Technical News Bulletin

Steinhausen, October 1998

Quick Change Cartridges 62-3036

**Quick Change Cartridge 62-3036
Group 8 shown**

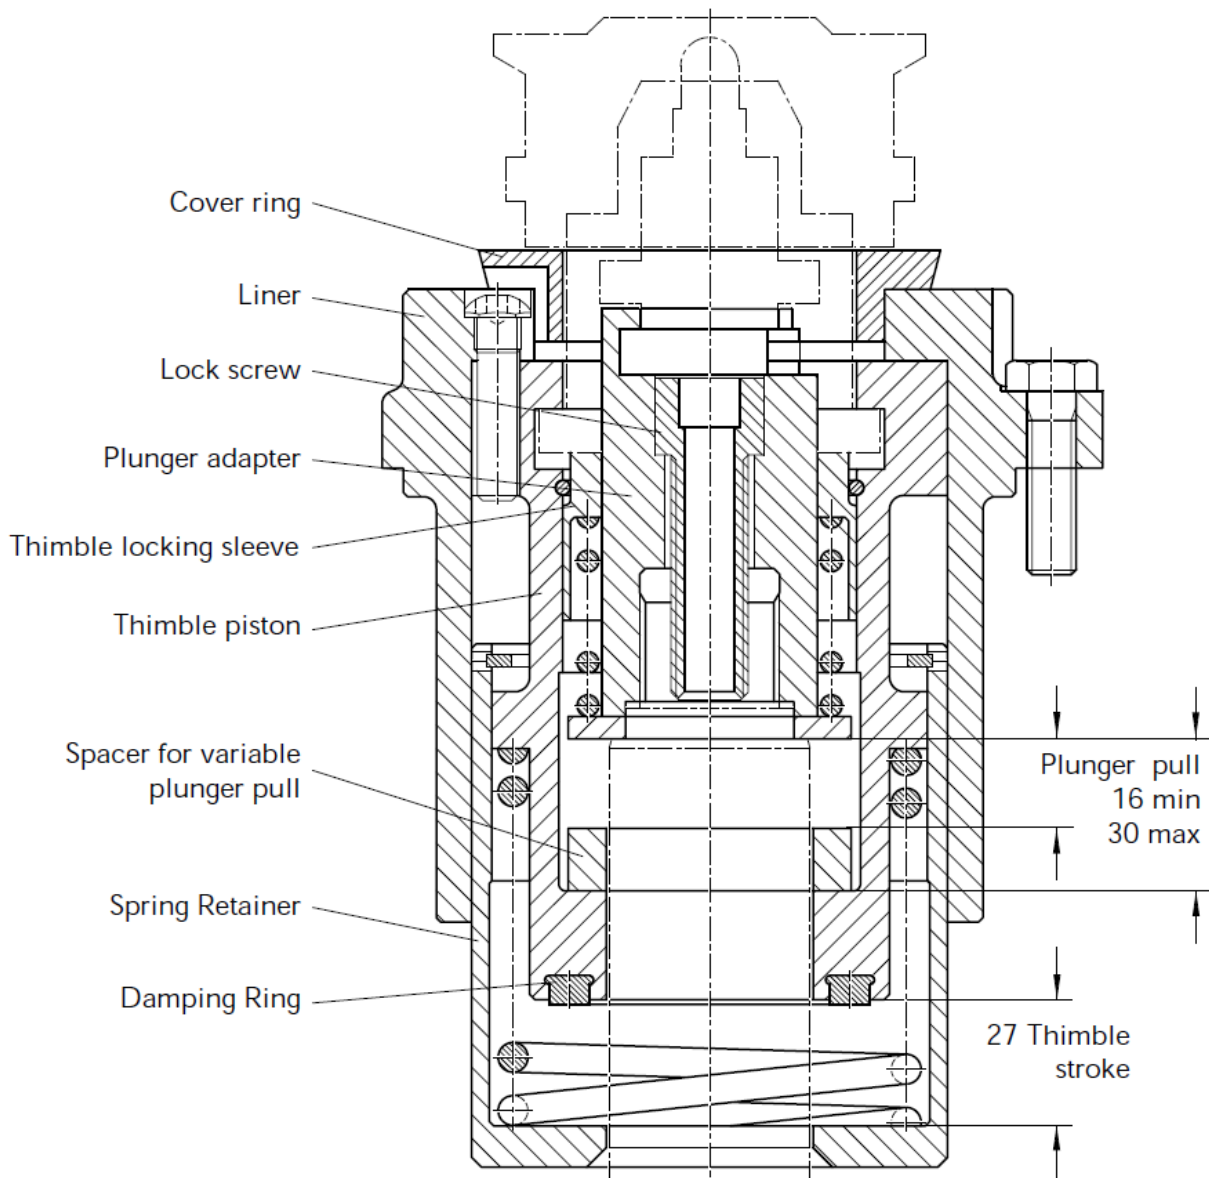
- ☐ **Self containing unit** - no loose parts remaining in the plunger mechanism after disassembly
- ☐ **Configurable plunger pull** - spacer ring allows to choose between 16 or 30 mm plunger pull. Improved counterblow with long plungers
- ☐ **Elastomeric damping ring** - absorbs thimble piston down stroke impact
- ☐ **Rigid spring retainer** - enhanced operation reliability
- ☐ **Horse shoe type plunger adapter** - easier plunger mounting and exchange
- ☐ **Adapter lock screw** - prevents loosening of adapter
- ☐ **Five assembly groups only for all center distance configurations** - the same basic parts used in all four groups, reduced inventory
- ☐ **Standardized finish equipment** - reduced mold equipment inventory

The new Quick Change Cartridges 62-3036 are designed for the application on Quick Change Plunger Mechanisms of all center distance configurations, excluding TG 3". As of March 1997 they are supplied as a direct replacement for the previous cartridges 62-3051 which will be no longer available as complete units. Spare parts for the previous cartridge, will be available until the end of the year 2001.
